SKEP III Home Office Support Site Visit Report

Consultant	Wahib Medanat Consultant Engineer	Rep No.	23-14052022
Contractor	Dijlah Establishment Constr. Contracting	Tender No.	(11/2019/USAID/SKEP/3/S) Schools for a Knowledge Economy Project (SKEP) - Phase (3) Package (1, 2)
Site Name	Jumana Bint Abit Taleb Basic Mixed School - Jerash	Day/ Date	Sat. 14/05/2022
Duration of Project	450 Calendar Days	Total Project Budget	8,314,983.735 JD

Visit Notes

(Figure: 17 & 18)

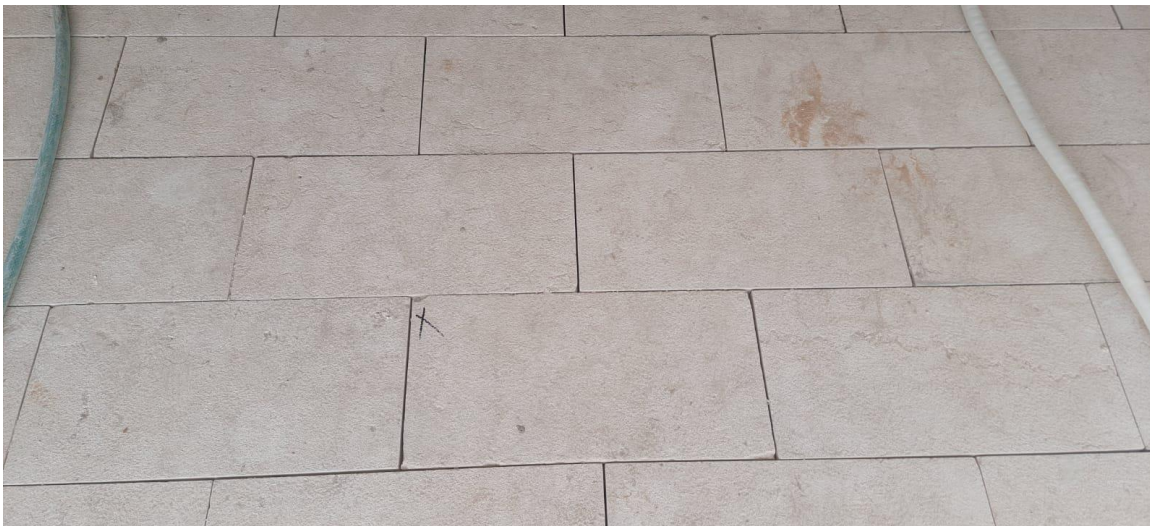
The team inspected the executed external stone steps. Notes were given to the Contractor to rectify
